Access Compliance Report

Public Rights-of-Way

(Curb Ramps)

Intersection ID: 10041415	Main Street: WESTHALL_DR	Cross Street: N/A	Location: E
ADA ID: 06F994AB917A	Ramp Type: PerpDiag	Initial Pass/Fail: Fail	Overall Compliance: No
Severity Score: 21.25			
Codes/Mitigation Info/Possible Solution		Field Measurements/Component Compliance

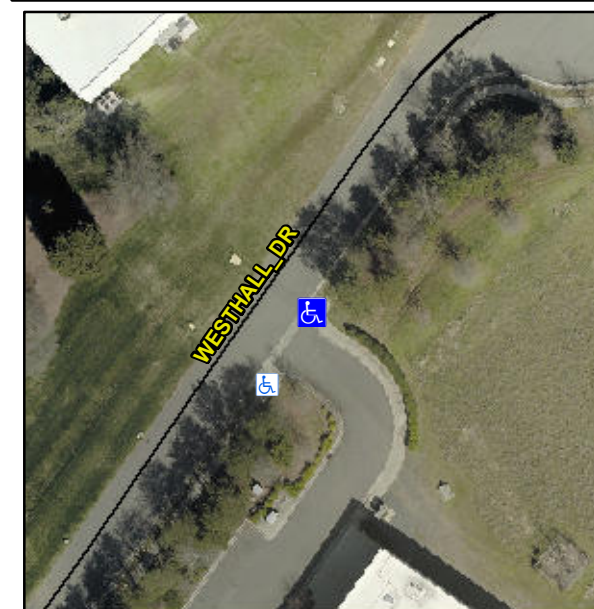
Not Found, R304.5.1, R304.5.3

Compliance	Description	Data	Compliance	Description	Data
N/A	Ramp Length (in)	77.0	Yes	Ramp Slope (%)	6.4
No	Ramp Width (in)	47.5	No	Ramp XSlope (%)	5.9
N/A	Flare Type LT	N/A	N/A	Flare Type RT	N/A
N/A	Flare Slope LT (%)	N/A	N/A	Flare Slope RT (%)	N/A
N/A	Flare Traversable LT?	N/A	N/A	Flare Traversable RT?	N/A
N/A	Landing Length (in)	N/A	N/A	DWS Provided?	N/A
N/A	Landing Width (in)	N/A	N/A	DWS Contrast?	N/A
N/A	Landing Slope (%)	N/A	N/A	DWS Length (in)	N/A
N/A	Landing X Slope (%)	N/A	N/A	DWS Full Width?	N/A
N/A	Landing Curb? (Y/N)	N/A	N/A	DWS Offset (in)	N/A
N/A	Shared Landing?	N/A			
N/A	Gutter Ponding?	N/A	N/A	Gutter Slope (%)	N/A
N/A	Gutter Lip Ht (in)	N/A	N/A	Gutter X Slope (%)	N/A
N/A	Painted X Walk1?	No	N/A	Painted X Walk2?	No
	X Walk 1 Direction	To NW		X Walk 2 Direction	To SW
N/A	X Walk 1 Width (in)	N/A	N/A	X Walk 2 Width (in)	N/A
	X Walk 1 Slope (%)	0.6		X Walk 2 Slope (%)	1.6
	X Walk 1 X Slope (%)	2.7		X Walk 2 X Slope (%)	2.9

Remove & Replace Curb Ramp With Two New Directional Ramps or Equivalent.
